- A. Thunderbolt Ignition - Spark When Switch "On" or "Off"
- B. Battery Lead and External Harness Installation - Merc 650
- C. Water Pump Impeller Installation
- D. Emergency Cowl Removal - 1974 Merc 110-75
- E. Bottom Cowl Drain - 1974 Merc 110-75

Figure 1. Internal Harness Connector and Battery Leads in Position

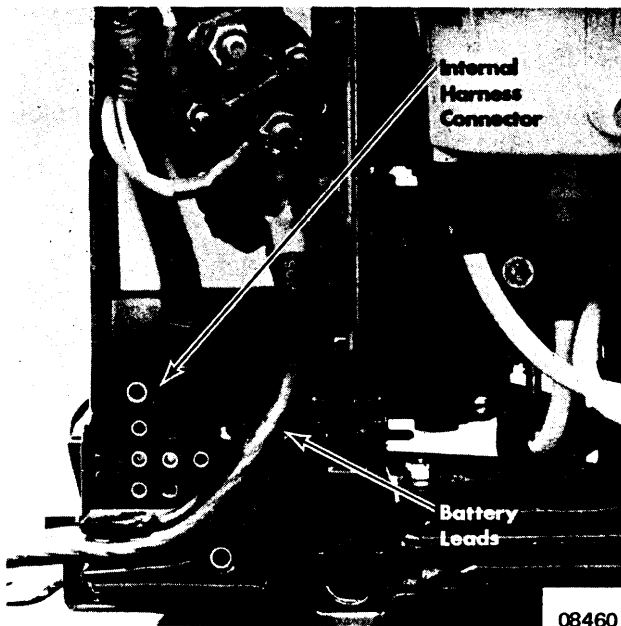
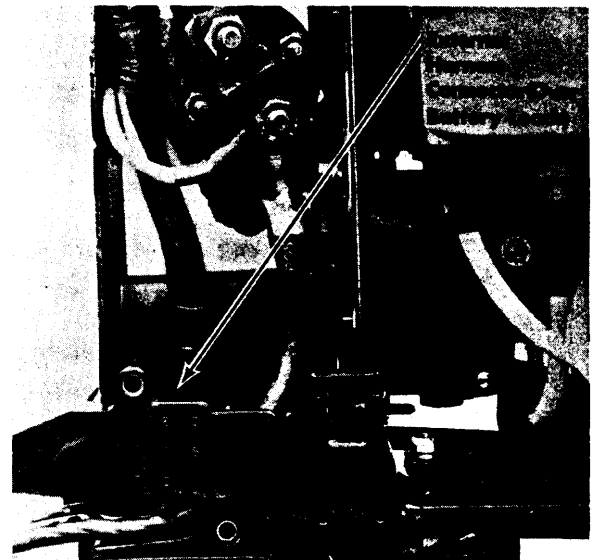
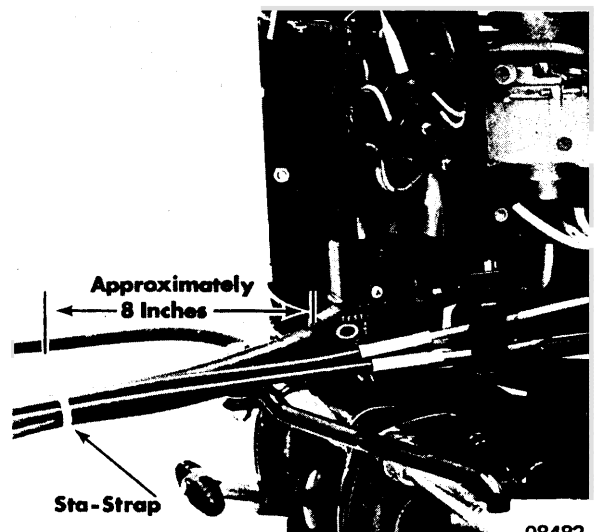
Mechanics and boat riggers are cautioned to properly install external harness and battery leads on Merc 650 Outboards as shown in Figures 1 and 2. Install a sta-strap around the harness, battery leads and control cables as shown in Figure 3.

Figure 4. Inserting Rod in Hole

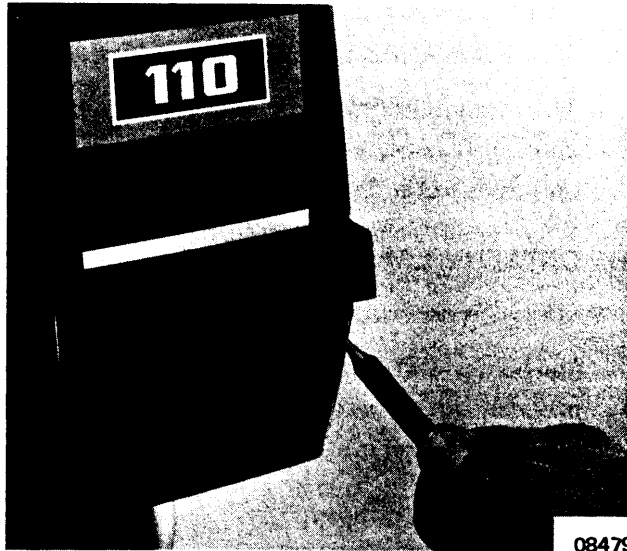
If the top cowl latch fails to function on a 1974 Merc 110-75, proceed as follows:

1. Insert a 11/64" (4.4mm) maximum diameter rod through the hole in the right rear of the bottom cowl, as shown in Figure 4.
2. Push the rod against the cowl release lever and remove the cowl by lifting off (up and forward).

Figure 5. Six 3/16" Diameter Holes in 1974 Merc 110-75 Models

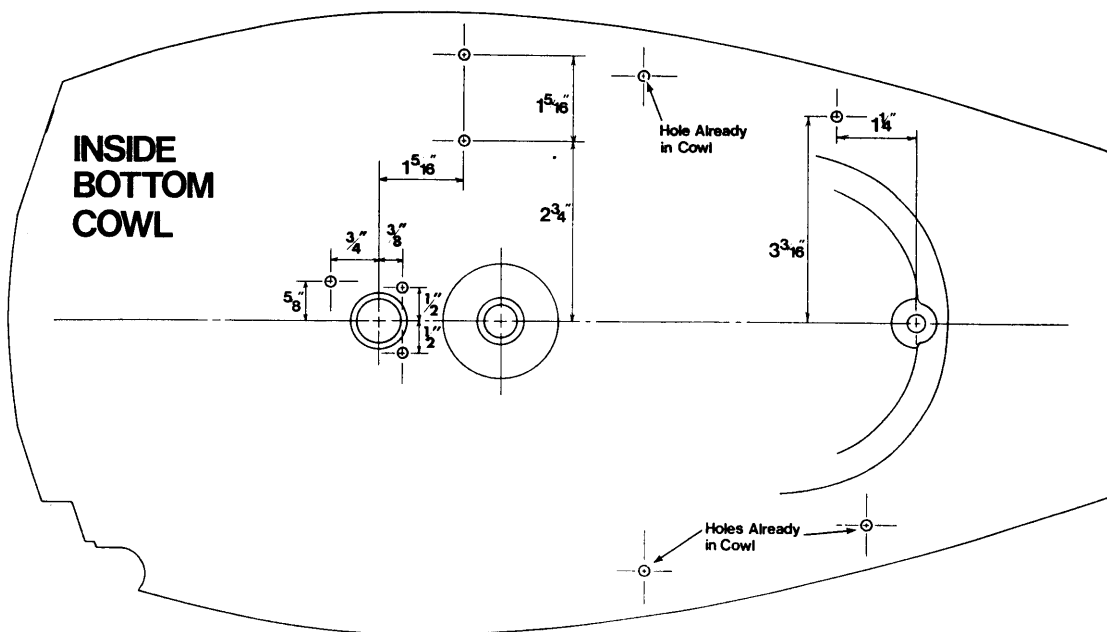
Model 1974 Merc 110-75 Outboards require 6 additional drain holes in the bottom cowl assembly. Drill the six 3/16" (4.8mm) diameter holes as shown in Figure 5.
